Nevada Division of Environmental Protection-Bureau of Air Quality Planning (NDEP-BAQP) BART Determination Review of Nevada Energy's Tracy Generating Station Units 1, 2 and 3

A BART analysis was completed by CH2M HILL at the request of Nevada Energy (NVE) for Units 1, 2 and 3 at the Tracy Generating Station (Tracy) dated October 3, 2008. Tracy consists of three BART eligible units with a generating capacity of 251 megawatts, of which Unit 1 is 55MW, Unit 2 is 83MW and Unit 3 is 113 MW. The Title V permit allows burning pipeline quality natural gas (PNG) or blended residual (No. 2 and No. 6 and non-PCB mineral oil) fuel oil. In completing the BART analysis, technology alternatives were investigated and potential reductions in NO_x, SO₂, and PM₁₀ emissions rates were identified. NVE's BART analysis is summarized below and organized according to the five step analysis contained Appendix Y in 40 CFR 51 Appendix Y of control options for sources subject to BART.

FIGURE 1

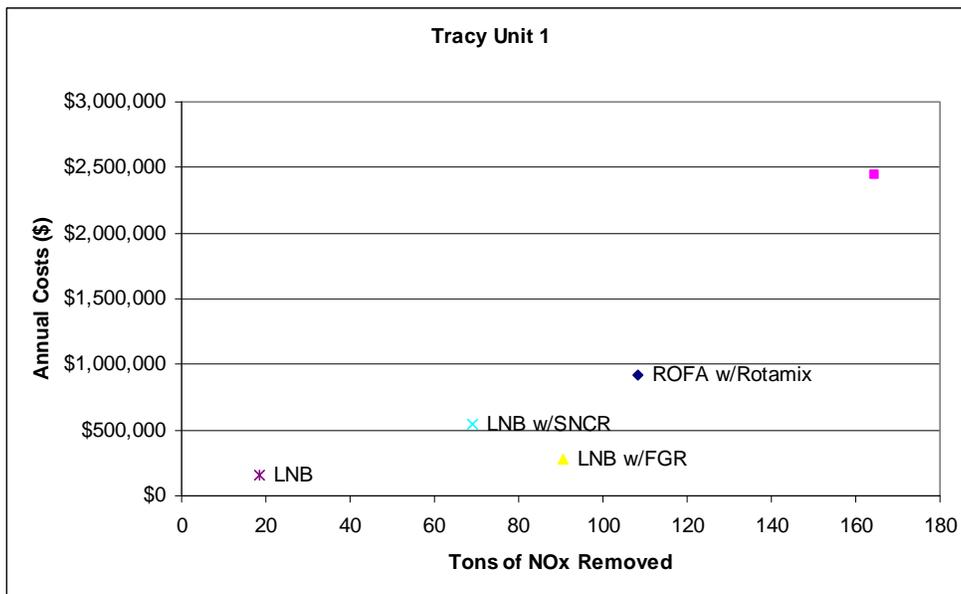
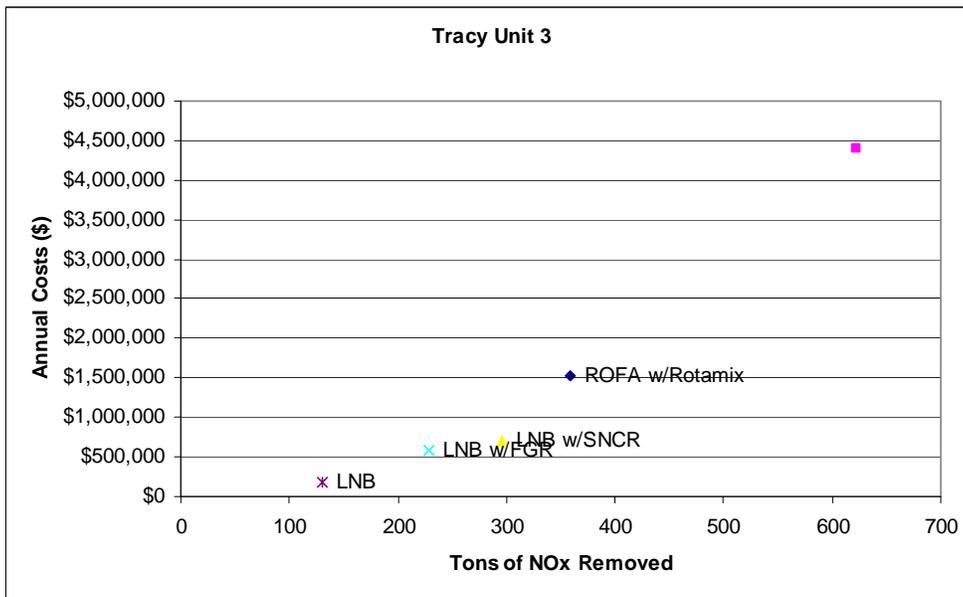
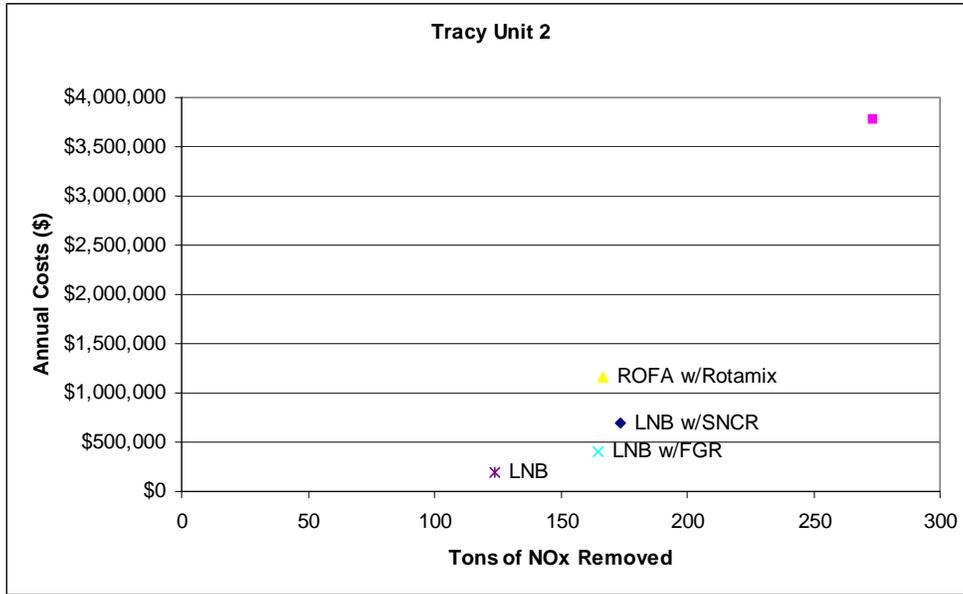
NDEP specifically reviewed the cost per ton of NO_x removed for each unit at Tracy and determined that installation of LNB with FGR for Units 1 and 2, as well as LNB with SNCR for Unit 3, meets the BART criteria. Associated costs range from \$2,383 to \$3,050/ton of NO_x removed. These values are considered cost effective. The cost data from the tables above are presented graphically for each unit in Figure 1. NDEP also concluded based on a review of the economic analysis that the \$/ton of NO_x removed increased significantly for LNB with SNCR, ROFA and SCR technologies without any clear environmental benefit.

Visibility improvement upon installation of LNB with FGR for Units 1 and 2 and LNB with SNCR for Unit 3 is anticipated to be greater than modeling with NVE's proposed BART limit presented in their October 2008 report. Modeling the visibility impact based upon the emission rates presented in Table 1 will be performed at a later date. Thereafter, data will be added to this report. Based on this review, the installation of LNB with FGR with an emission level at 0.15 lb/MMBtu for Unit 1 and 0.12 lb/MMBtu for Unit 2, as well as LNB with SNCR with an emission level at 0.19lb/MMBtu for Unit 3, on a 12-month rolling average, is BART.
